HEARING DATE: May 4, 2023

SUBJECT: Bordeaux Estates
H-2022-0062

Annexation of two (2) acres of land with an R-8 zoning district; and combined preliminary & final plat consisting of four (4) building lots and one (1) common lot on 2.22-acres of land in the R-8 zoning district for Bordeaux Estates Subdivision.

C. Final Plat (dated: 1/20/2023)

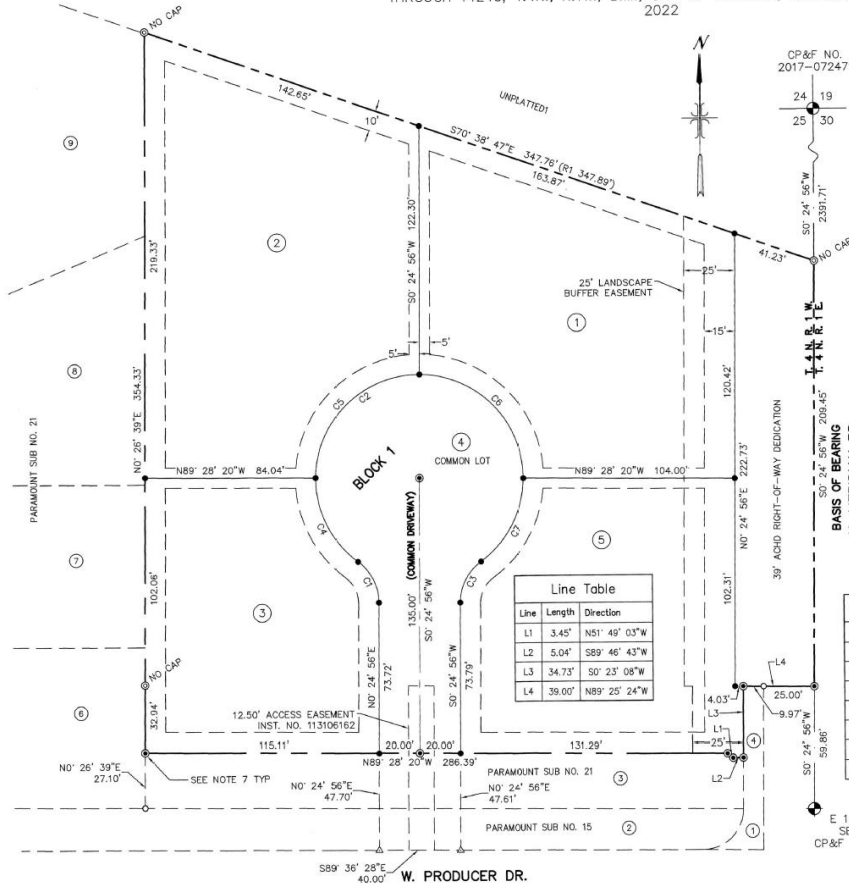
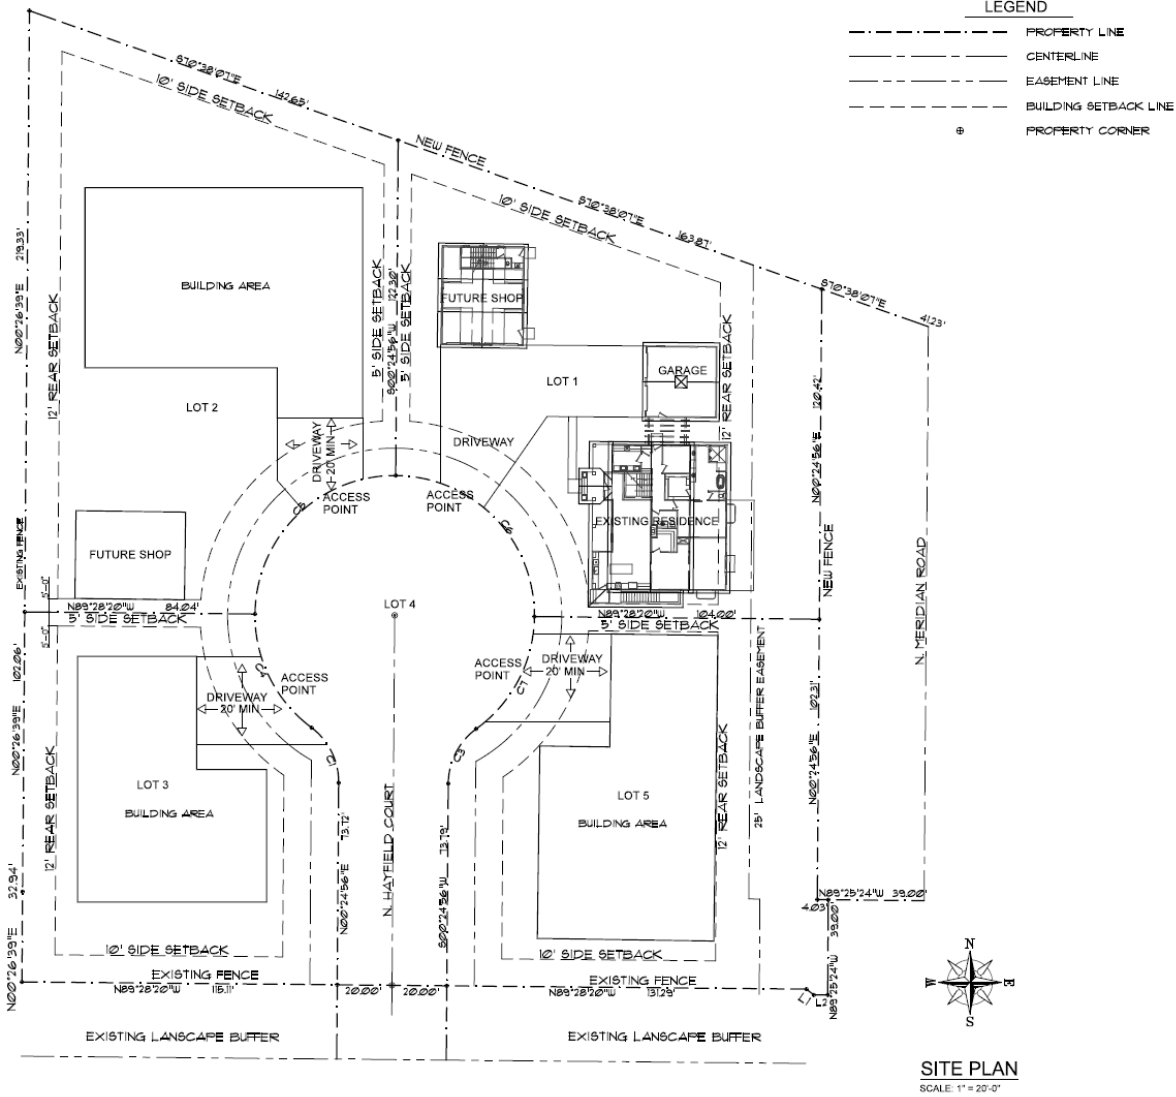
nonconforming structure as defined in UDC [11-1A-1](#). **The symbols for the “adjacent lot line” and the “easement” appear to be the same on the final plat; change one of them to another symbol.**

Landscaping (UDC [11-3B](#)): A 25-foot wide street buffer is depicted on the plat along N. Meridian Rd. **The buffer is required to be widened to 35-feet in accord with UDC Table [11-2A-6](#) as Meridian Rd. is classified as an entryway corridor; the buffer should be landscaped in accord with the standards listed in UDC [11-3B-7C](#). Additional landscape design features are required within landscape buffers along entryway corridors per the standards in UDC [11-3B-7C.3f](#). The proposed buffer incorporates a 3:1 berm with a boulder wall at the back edge of the buffer at a maximum height of 3-feet.** Alternative compliance may be requested to the width of the street buffer as set forth in UDC [11-3B-7C.1c](#); however, a reduction to the buffer width shall not affect building setbacks – all structures shall be set back from the property line a minimum of the buffer width required in the district (except for nonconforming structures).

2. The final plat submitted with the final plat for City Engineer signature shall include the following revisions:
 - a. Depict a 35-foot wide street buffer along N. Meridian Rd., an entryway corridor, per UDC [Table 11-2A-6](#), in a permanent dedicated buffer or a common lot. The buffer shall be measured from the ultimate curb location as anticipated by ACHD.

- b. Depict a 10-foot wide detached sidewalk within the street buffer along N. Meridian Rd. with an average minimum separation of greater than four (4) feet to back of curb.

- c. Note #8: Modify the blanket ingress-egress easement to include the requirement for maintenance of a paved surface capable of supporting fire vehicles and equipment; or, submit a copy of a separate recorded easement as noted below in condition #5.

- d. Depict the location of the ingress-egress easement over Lot 2, Block 49, Paramount Sub. No. 15 and Lot 3, Block 49, Paramount Sub. No. 21 and include the recorded instrument number of the easement.

- e. The symbols for the “adjacent lot line” and the “easement” appear to be the same on the final plat; change one of them to another symbol.

D. Common Driveway Exhibit – NOT APPROVED

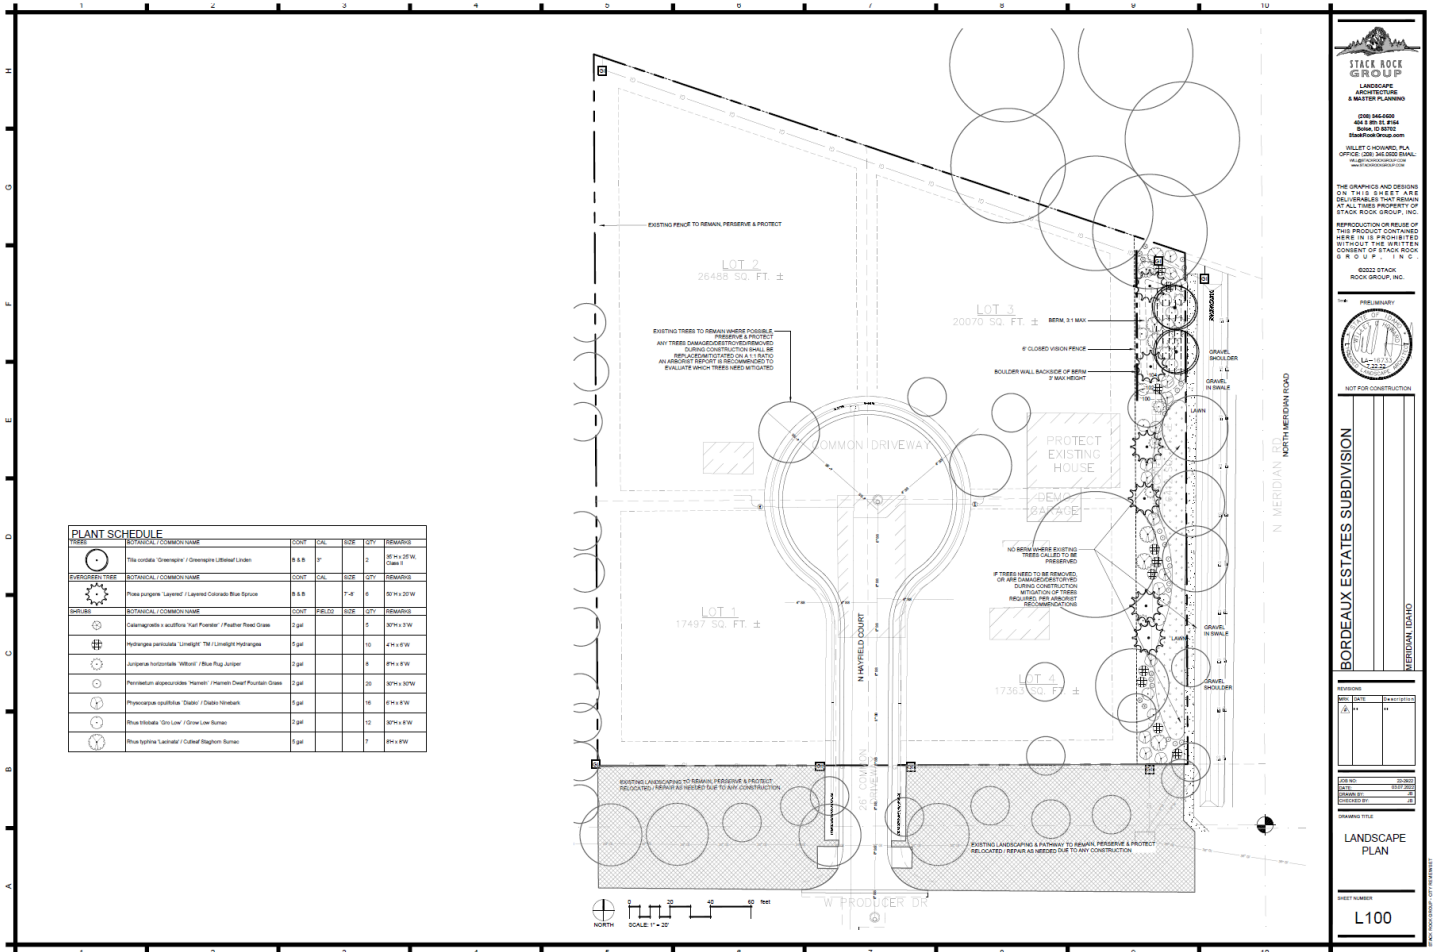
Access: Access is proposed via a common driveway from W. Producer Dr., a residential collector street adjacent to the southern boundary of this site. A common driveway exhibit was submitted as shown in Section VIII.C that complies with the standards listed in UDC [11-6C-3D](#); **however, the setbacks for Lots 1 and 2 depicted on the exhibit do not all comply with the minimum setbacks for the R-8 district and a 35-foot wide landscape buffer is required, not a 25-foot wide buffer. The exhibit should be revised prior to the Council hearing to reflect compliance with the dimensional standards [i.e. the north side of Lot 2 should be the rear setback and the west side should be the side setback; the existing home appears to encroach within the rear and possibly the (south) side setback; the street buffer needs to be widened to 35-feet; and the fence along Meridian Rd. (if proposed) needs to be placed on the interior edge of the street buffer].**

The Applicant shall revise the common driveway exhibit in Section VIII.D per the analysis in Section VI.B prior to the City Council hearing.

- d. Depict fencing (if proposed) at the interior edge of the street buffer along N. Meridian Rd.
4. The common driveway shall comply with the standards listed in UDC [11-6C-3D](#).

Lot 1 Existing House/ Remodel and Addition

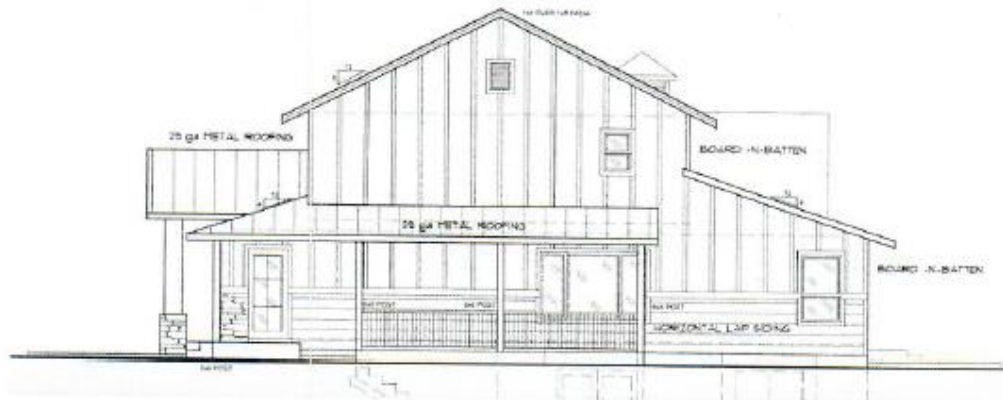
Building Elevations: One (1) conceptual building elevation for Lots 2, 3 and 5 and one (1) conceptual elevation of the remodeled existing home on Lot 1 with a new addition and detached garage in a modern farmhouse design was submitted as shown in Section VIII.F. Building materials consist of hardi or LP board & batten siding mixed with 8" lap siding, merril stone and natural wood accents, and architectural asphalt shingles with standing seam metal roof accents. Design review is not required for single-family detached structures. However, because the rear and/or sides of homes facing N. Meridian Rd. and W. Producer Dr. will be highly visible, those elevations should incorporate articulation through changes in two or more of the following: modulation (e.g. projections, recesses, step-backs, pop-outs), bays, banding, porches, balconies, material types, or other integrated architectural elements to break up monotonous wall planes and roof lines that are visible from adjacent public streets.

- f. The rear and/or sides of homes facing N. Meridian Rd. and W. Producer Dr. shall incorporate articulation through changes in two or more of the following: modulation (e.g. projections, recesses, step-backs, pop-outs), bays, banding, porches, balconies, material types, or other integrated architectural elements to break up monotonous wall planes and roof lines that are visible from the subject public streets.
